NASA/TM-2007- 215084
NESC-RP-07-13/06-050-E

Independent Review Support for Phoenix Mars Mission Robotic Arm Brush Motor Failure

NASA Engineering and Safety Center Technical Report	Document #: RP-07-13	Version: 1.0
Title: Independent Review Support for Phoenix Mars Mission Robotic Arm Brush Motor Failure			Page #: 1 of 54

The Phoenix Project requested the NASA Engineering and Safety Center (NESC) perform an independent peer review of the Robotic Arm (RA) Direct Current (DC) motor brush anomalies that originated during the Mars Exploration Rover (MER) Project and recurred during the Phoenix Project. The request was to evaluate the Phoenix Project investigation efforts and provide an independent risk assessment. This includes a recommendation for additional work and assessment of the flight worthiness of the RA DC motors.

Figure 6.1-1. Motor Brush Anomalies – Tip Failure (Left) and Pivot Failure (Right)

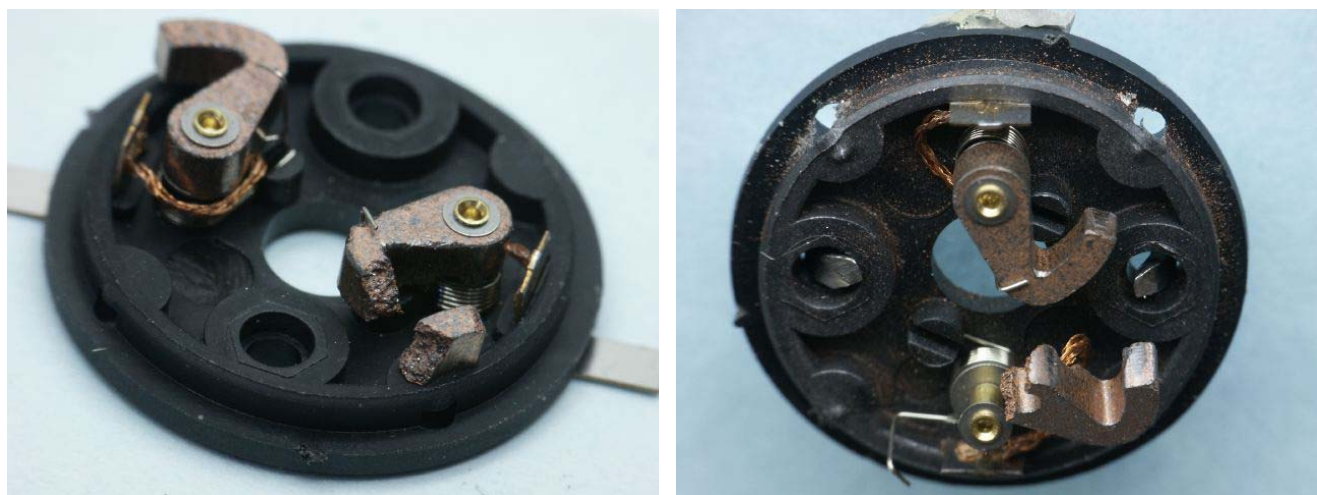
The anomalies with these motors occur in the commutating brushes. There are two failure modes that have been identified which are a concern for mission success (shown in Figure 6.1-1).

Figure 7.0-1. Image 6304 Motor N-Ray Image (Brushes Intentionally Not in Position)

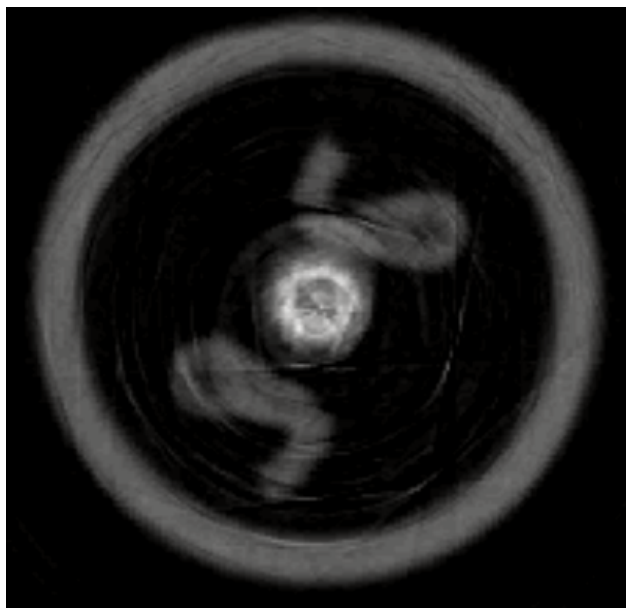
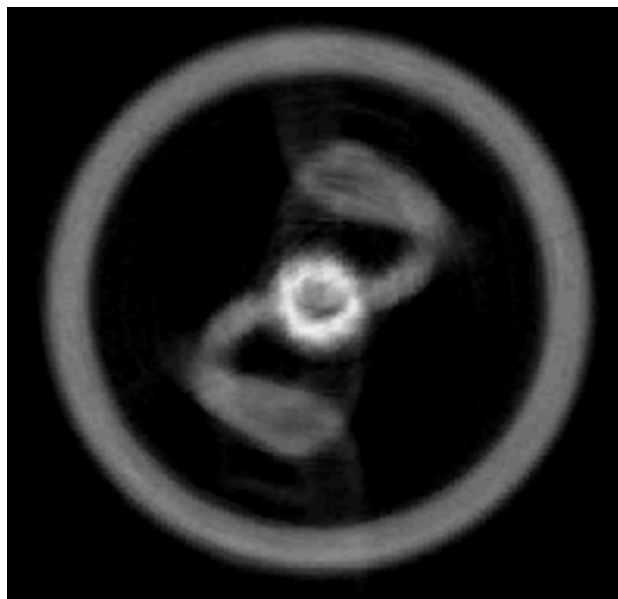
Figure 7.0-1 (Image 6304) depicts the interior of a partial motor assembly (missing the encoder assembly). The brushes were intentionally installed incorrectly by not spring-preloading against the commutator. If N-ray could not detect this workmanship flaw, then it was doubtful N-ray would be beneficial as a rigorous nondestructive tool.

As Figures 7.0-1 and 7.0-2 shows, the graphite brushes are distinctive in both scans. When the images were magnified and slowly stepped through the sequential scans, some variation in the "density" of the brush was observed. This density variation however, is an artifact of the scan-and-reconstruction process. The use of N-ray beyond the detection of macroscopic breaks in the brushes would require an involved development effort to determine if flaws or pre-existing cracks could be detected.

1. N-ray imaging can distinguish the copper/graphite brushes within an assembled motor.
2. Gross workmanship errors and, potentially, macroscopic brush breakage can be detected by N-ray scan imaging without destructive disassembly of the motor.
3. N-ray scans should be able to detect a brush "tip break", or the brush "pivot break not displaced from the pivot".
4. N-ray should be able to penetrate any metallic overshield or housings around an integrated motor. However, it is currently not known whether Kapton™¹ tape overwrap or Kapton™ film heaters around a motor, integrated at the next level of assembly, would interfere with the imaging.
